Our Case Number: ACP-322958-25

Re: Athlone link road phase 2. Proposed link road, joining the Crescent Junction (R915) to Southern Station Road Junction
Athlone, County Westmeath

Observation Re: ACP-322958-25
Athlone Link Road Phase 2 Joining The Crescent Junction (R915) to Coosan Point Road/
Southern Station Road Junction in Athlone, County Westmeath.

Proposed Athlone Link Road Phase 2 and Proposed Reconfiguration and Extension of Athlone Bus Eireann Depot Yard

Figure 1: OPW Floodmaps Extract
From Drainage Design Report Section 2.1

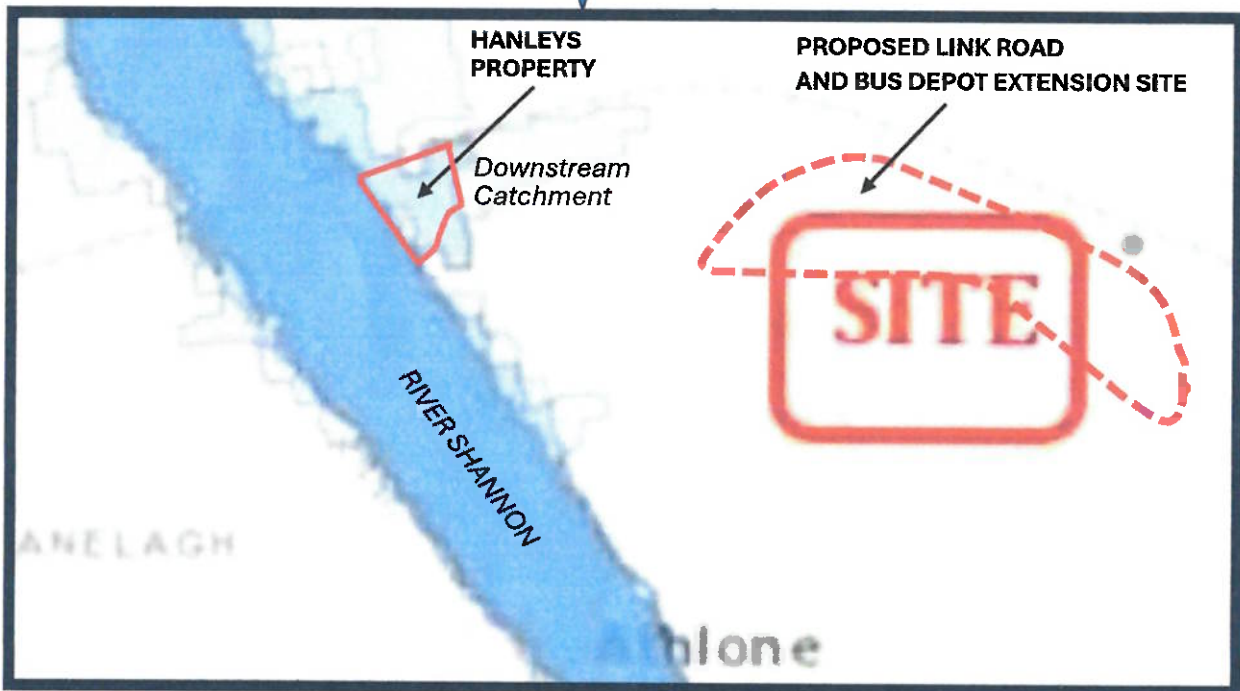
- (b) The property which was impacted in 2009 and 2015 by 1:100 year floods (AEP 1% and 1.1% respectively) is located in a flood prone area, (refer to attached Map No. 1, - *extract from OPW Floodmap*).

Extract from above section of OPW Floodmap with Notes added
